ENQUIRY RESULTS

prEN 50549-1 Title: Requirements for generating plants to be connected in parallel with distribution networks - Part 1-1: Connection to a LV distribution network – Generating plants up to and including Type A	Submission: 2017-05-26 Deadline: 2017-08-18 Subsector: U95 Project: 63319 TC(s): CLC/TC 8X Directive(s): RfG (2016/631) Mandated: M/490 Supersedes: EN 50438:2013 EN 50438:2013/IS1:2015 CLC/TS 50549-1:2015
---	---

Figure A

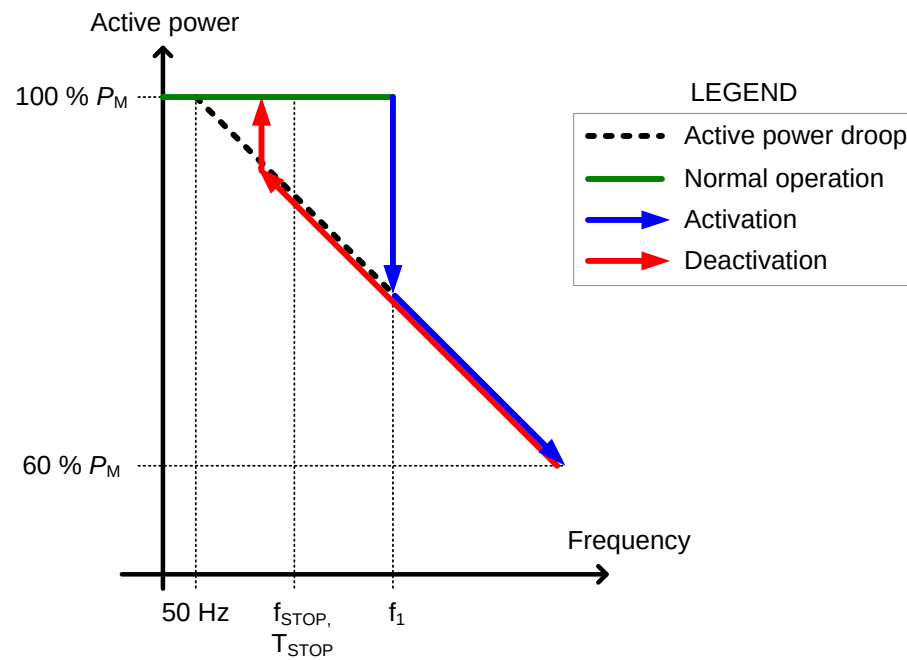
MB/ NC	Line number	Clause/ Subclause	Paragraph/ Figure/ Table	Type of comment	Comments	Proposed change	Proposed Observations	Prio 1 2 3
SI-3	0731 to 756	4.6	Whole paragra ph 4.6	te	Characteristics on proposed Figure A enables different operating islands (in the TSO and/or DSO network) to be reconnected. With the current characteristics depicted on Figures 9 and 10 that is not possible. Dead band depicted on Figures 9 and 10 can lead to: - Frequency mismatch of two islanding systems thus prohibiting their resynchronisation. - With reference power manipulation, frequency closer to 50Hz can't be achieved (almost by default, frequency error will be at the frequency f_1). (See Figure A enhanced below the table)	Replace Figures 9 and 10 with proposed figure A.  Figure A	rejected Proposal rejected as not jet used in Europe.	1
PL-21	0732	4.6.1	Figure 9	ed	The titles of figures start with capital letter (see previous figure titles).	Change the word “active” onto word “Active”.	Accepted	3

Bild C.3 – Veranschaulichung bei $3 \tau = 10 \text{ s}$

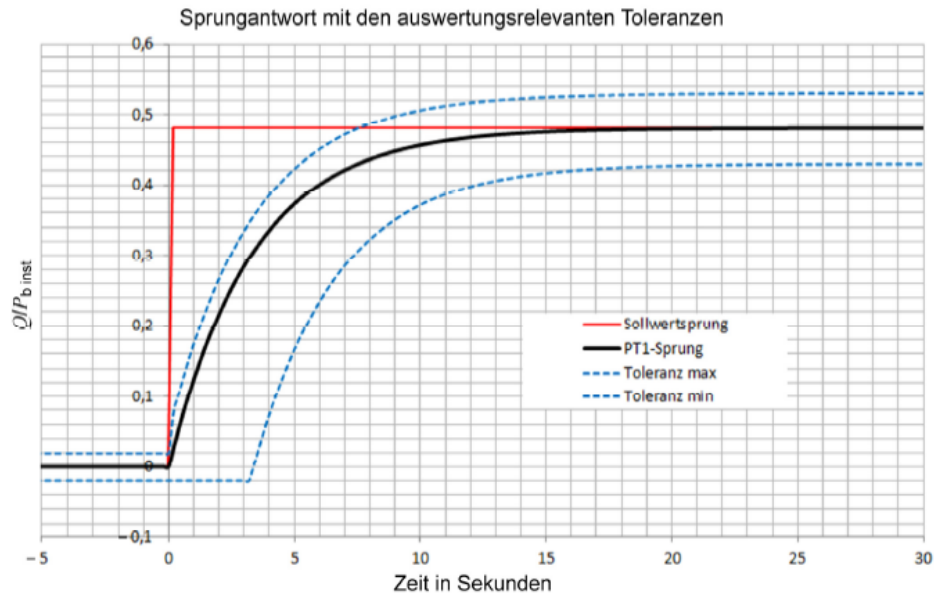
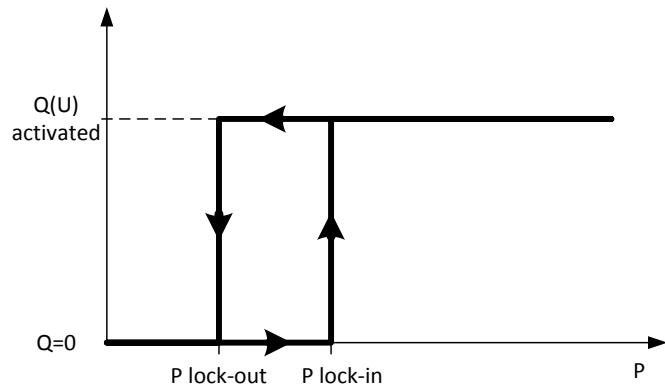
The tolerance in time shall be -0/+3sec or -0/+2* τ , whatever is the larger. The tolerance of Q during dynamic operation shall be: +-10% of S_n .
